PM7350

S/UNI-DUPLEX

DEVICE ERRATA

Issue 4: May 2001

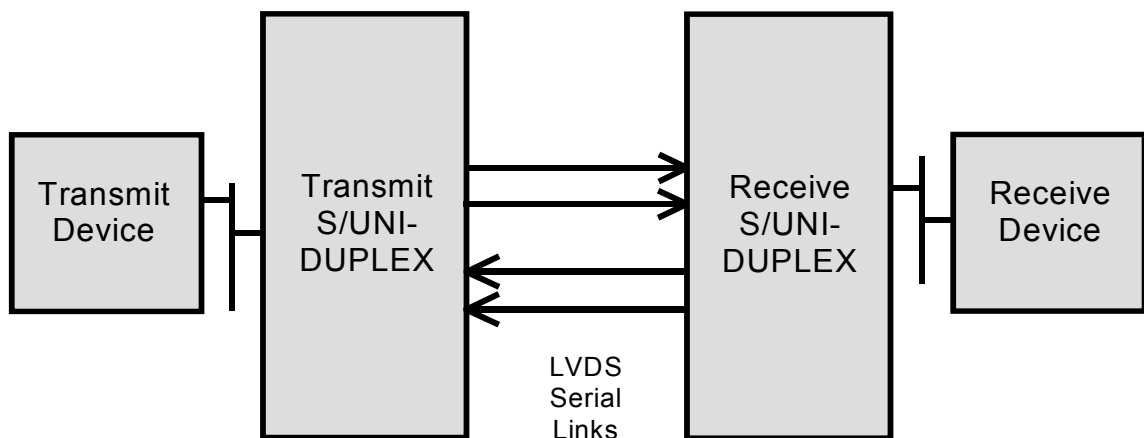
When using two S/UNI-DUPLEXs “back-to-back” as a UTOPIA serializer, the backpressure mechanism may limit the data throughput to no more than one half of the theoretical maximum throughput of the LVDS link¹.

In order to understand the root cause and resolution of this behavior, it is important to understand the backpressure mechanism used by the S/UNI-DUPLEX. The simplified configuration shown in the diagram below will be used for this discussion. In this case it is assumed that there is only one active logical channel being used.

The high speed serial interface (LVDS) links utilize a cell-based data structure which consists of the ATM user data and a system prepend². Included in this system prepend is per-PHY flow control information which enables the S/UNI-DUPLEX to implement a backpressure mechanism. The S/UNI-DUPLEX uses backpressure to control cell flow and prevent cell loss due to bursts in traffic from a PHY on a logical channel. Backpressure information is sampled and sent every second LVDS cell, i.e., one LVDS cell contains backpressure information for 16 logical channels while the next LVDS cell contains backpressure information for the remaining 16 logical channels. Cells are sent continuously over the LVDS link. If no user cells are available to be sent, idle cells are inserted in their place to carry the backpressure information. These idle cells are discarded at the receiving S/UNI-DUPLEX.

On the LVDS receive interface, the S/UNI-DUPLEX has a four cell FIFO per channel and asserts backpressure if there are two or more cells in this FIFO³. Because backpressure information for a specific logical channel is sent every second cell, the FIFO must accommodate up to two additional cells which may be sent before the transmit S/UNI-DUPLEX receives and responds to the backpressure information. Without this two cell headroom, cells could be lost due to FIFO overflow. The transmit S/UNI-DUPLEX cannot resume sending cells on the logical channel until the backpressure is cleared. During this time, the transmit S/UNI-DUPLEX will send idle cells over the LVDS link⁴. When the receive S/UNI-DUPLEX FIFO contains less than two cells, the backpressure status is de-asserted and sent to the transmit S/UNI-DUPLEX which can then resume sending cells.

It is important to note that when the first payload byte of a cell received from the LVDS bit stream is written into the FIFO, the FIFO cell position is considered filled. When the last byte of a cell transferred to the bus is read from the FIFO, the FIFO cell position is considered empty. Therefore, if a cell is being written into the FIFO from the LVDS link at the same time another cell is being read out of the FIFO via the Utopia bus, the FIFO is considered “near full” and backpressure is asserted. Even if a cell is read out of the FIFO immediately following the transmission of the backpressure information, the backpressure status cannot not be updated for two LVDS cell times. After this delay, the transmit S/UNI-DUPLEX is permitted to start sending cells again. Depending on the relative phase and frequency of cells being written into the FIFO (i.e. the cell rate on the LVDS link) and cells being read out of the FIFO (i.e. the cell rate of the PHY device receiving the cells via the UTOPIA bus interface), the backpressure status could continue to alternate between asserted and cleared indefinitely. This would result in only one half of the LVDS link bandwidth being utilized by user cells with the remainder carrying idle cells.

This backpressure cycling can be modified by increasing the “FIFO near-full” threshold level from 2 to 3 via the undocumented Receive Channel FIFO Ready Level (Register 0x3F). Changing this fill level does not increase the total number of cells in the FIFO – it still remains at four cells. Therefore, by increasing the FIFO full level to 3 the headroom in the FIFO is reduced from two cells to one cell. As mentioned previously, this could result in FIFO overflow if the receiving device does not drain at least one cell from the FIFO in the time it takes the LVDS link to write in the two cells that may arrive due to the backpressure latency.
